Product Discontinuation Notices

Product Discontinuation

Model FH-SC

Model FH-SM

[Difference from discontinued product]

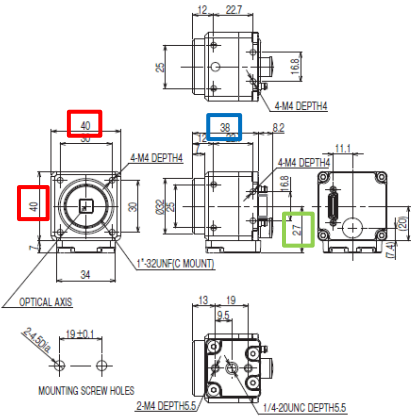
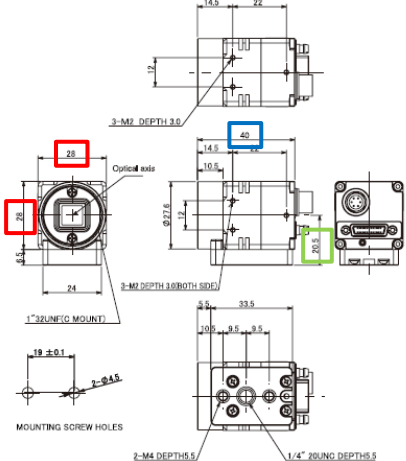
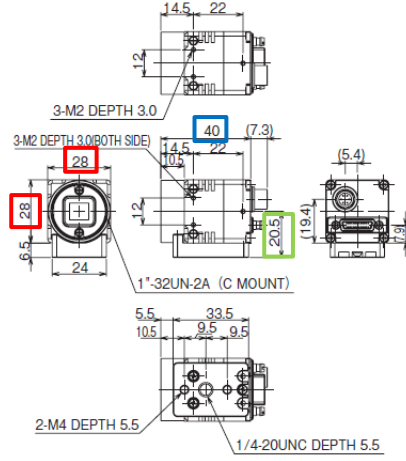
It's different in dimensions, so reconsideration of the installation environment according to the specification of the camera after change, please.

Recommended replacement Model	Body Color	Dimensions	Wire connection	Mounting Dimensions	Characteristics	Operation ratings	Operation methods
FH-SCX	◎	×	○	◎	×	×	◎
FZ-SC	◎	×	○	◎	×	×	◎
FH-SMX	◎	×	○	◎	×	×	◎
FZ-S	◎	×	○	◎	×	×	◎

[Product Discontinuation and recommended replacement]

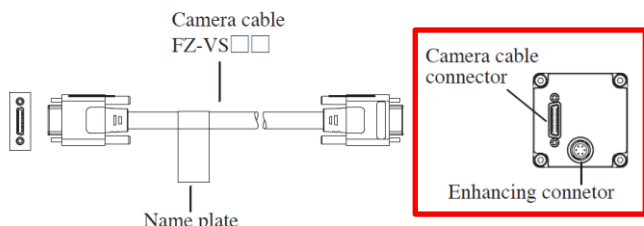
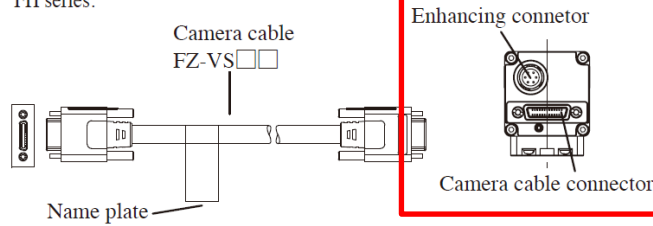
Product discontinuation	Recommended replacement
FH-SC	FH-SCX
	FZ-SC
FH-SM	FH-SMX
	FZ-S
